# Access Compliance Report

## Public Rights-of-Way

Intersection ID: 26725	Main Street: BEACON_FOREST_DR	Cross Street: MANOR_HOUSE_DR	Location: SW
ADA ID: E309677B665F	Ramp Type: BlendTrans1	Initial Pass/Fail: Fail	Overall Compliance: No
Severity Score: 10			
Codes/Mitigation Info/Possible Solution		Field Measurements/Component Compliance

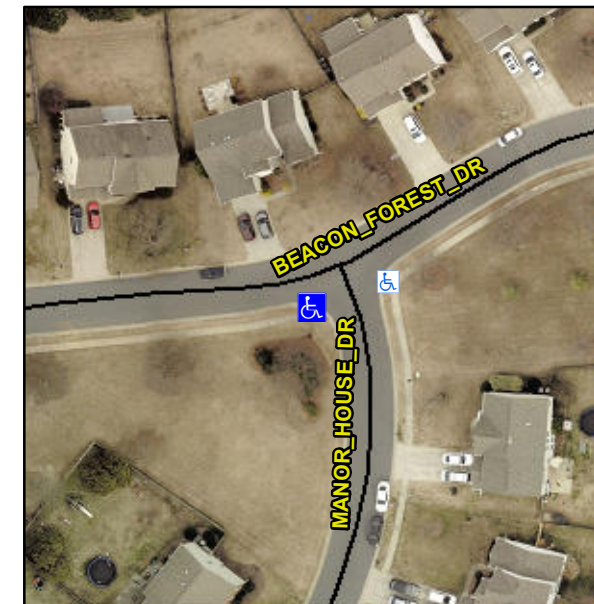
**Not Found, R304.5.1, R304.5.3**

Compliance	Description	Data	Compliance	Description	Data
N/A	Ramp Length (in)	48.0	Yes	BlendTrans Slope (%)	2.1
No	Ramp Width (in)	42.0	No	BlendTrans XSlope (%)	4.0
N/A	Flare Type LT	N/A	N/A	Flare Type RT	N/A
N/A	Flare Slope LT (%)	N/A	N/A	Flare Slope RT (%)	N/A
N/A	Flare Traversable LT?	N/A	N/A	Flare Traversable RT?	N/A
N/A	Landing Length (in)	N/A	N/A	DWS Provided?	N/A
N/A	Landing Width (in)	N/A	N/A	DWS Contrast?	N/A
N/A	Landing Slope (%)	N/A	N/A	DWS Length (in)	N/A
N/A	Landing X Slope (%)	N/A	N/A	DWS Full Width?	N/A
N/A	Landing Curb? (Y/N)	N/A	N/A	DWS Offset (in)	N/A
N/A	Shared Landing?	N/A			
N/A	Gutter Ponding?	N/A	N/A	Gutter Slope (%)	N/A
N/A	Gutter Lip Ht (in)	N/A	N/A	Gutter X Slope (%)	N/A
N/A	Painted X Walk1?	No	N/A	Painted X Walk2?	N/A
	X Walk 1 Direction	To NE		X Walk 2 Direction	N/A
	X Walk 1 Width (in)	N/A		X Walk 2 Width (in)	N/A
	X Walk 1 Slope (%)	1.7		X Walk 2 Slope (%)	N/A
	X Walk 1 X Slope (%)	3.8		X Walk 2 X Slope (%)	N/A

N/A	Ramp inside XWalk1?	N/A	N/A	Ramp inside XWalk2?	N/A
	Road Slope (%)	3.8		Clear Space?	N/A
	Road X Slope (%)	1.7	N/A	Clear Space to XWalk (in)	N/A
N/A	Any Obstructions?	N/A	N/A	Storm Grate/Utility Hazard?	N/A
	Obstruction Type			Storm Grate/Utility Type	
		N/A			N/A
			Yes	Surface Condition? (G/P)	Good
			No	Curb Slope (%)	13.4

**Remove & Replace Curb Ramp With Two New Directional Ramps or Equivalent.**
